PRODUCT BULLETIN 36138

MWM Engine Failures and Preventative Maintenance

Prepared by: Australian Mining Equipment

Communication: MWM Engine Failures & Preventative Maintenance

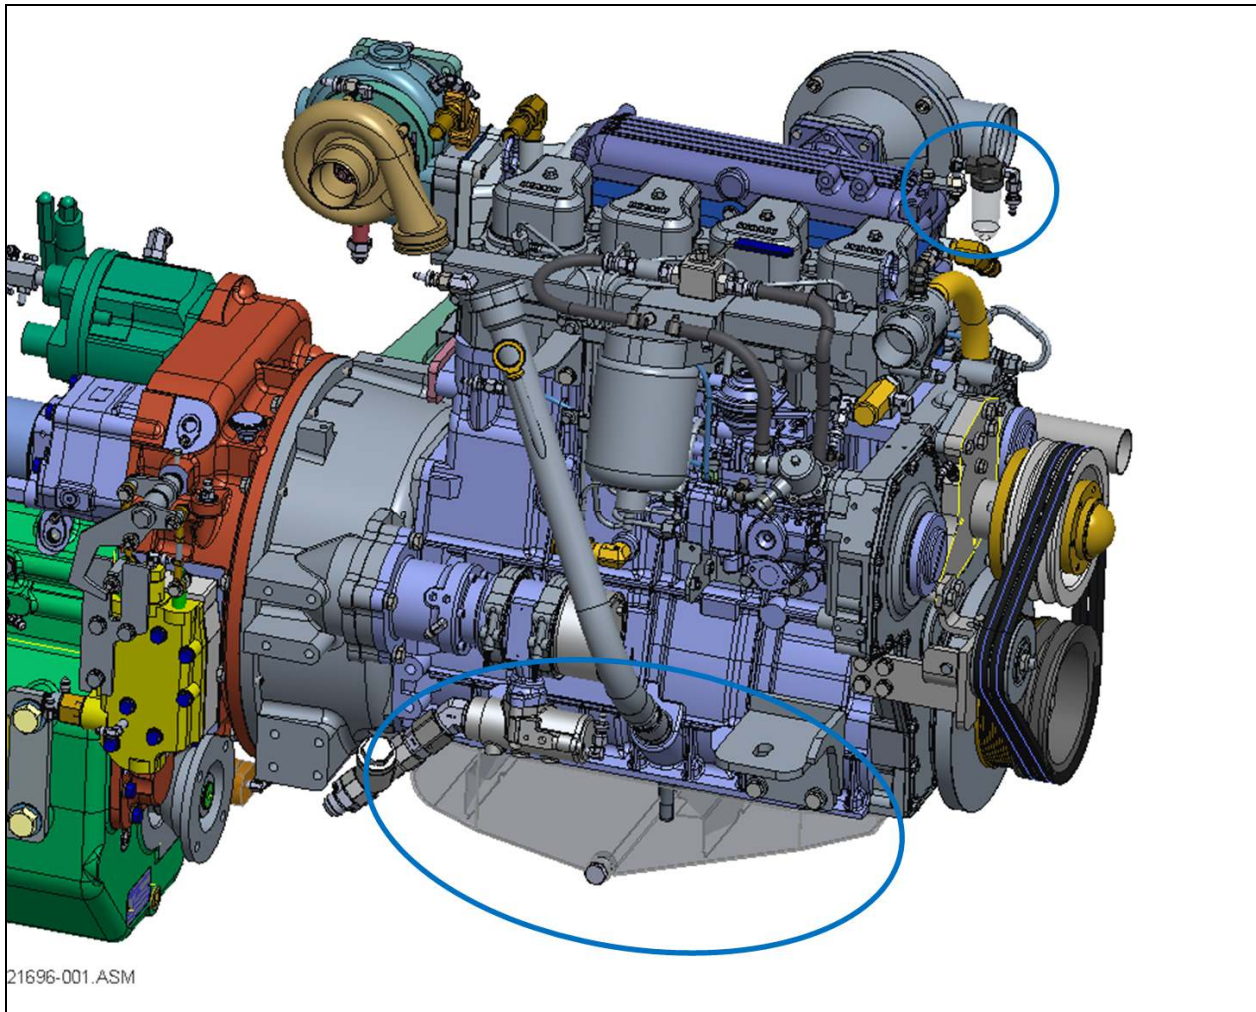
The connecting rod bearings had suffered significant wear and slipped whilst in situ on the number one big end connecting rod (prior to failure of connecting rod cap).

The piston top edge had made metal to metal contact with the liner.

A significant oil leak was found on the supply line.
